**R22 SERVICE LETTER SL-87**

**R44 SERVICE LETTER SL-73**

**SUBJECT:** Main and Tail Gearbox Oil

**ROTORCRAFT AFFECTED:** All R22-series and R44-series helicopters.

**FIGURE 1**

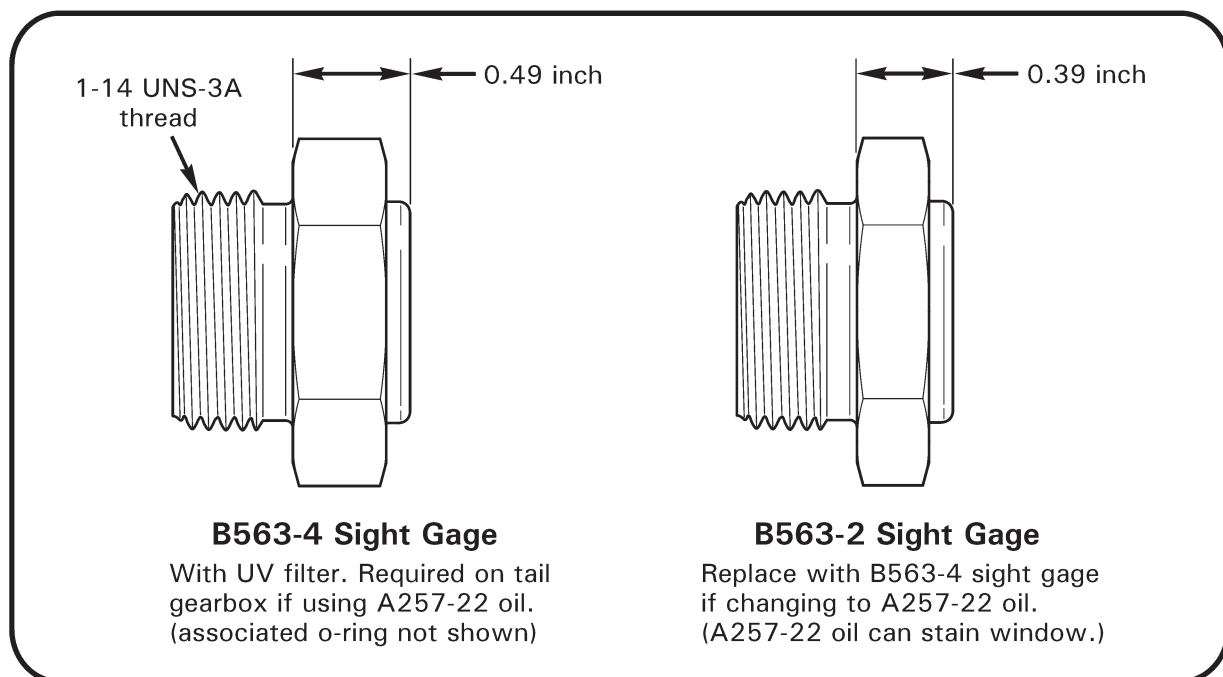
1. All R22 & R44 gearboxes (including new) may use A257-2 (traditional, blue) oil if more convenient or desired. Drain and flush per Maintenance Manual (MM) if converting from A257-22 oil.
2. Tail gearboxes are eligible for A257-22 oil provided a B563-4 sight gage is installed (refer to Figure 1); not all tail gearboxes can be retrofitted with the B563-4 sight gage (due to thread differences).
3. A006 R22 main gearboxes with A146-1 Revision Q & subsequent pinion are eligible for A257-22 oil. A146-1 pinion data plate is adjacent A006 gearbox data plate.
4. C006 R44 main gearboxes with C146-2 Revision Q & subsequent pinion are eligible for A257-22 oil. C146-2 pinion data plate is adjacent C006 gearbox data plate.
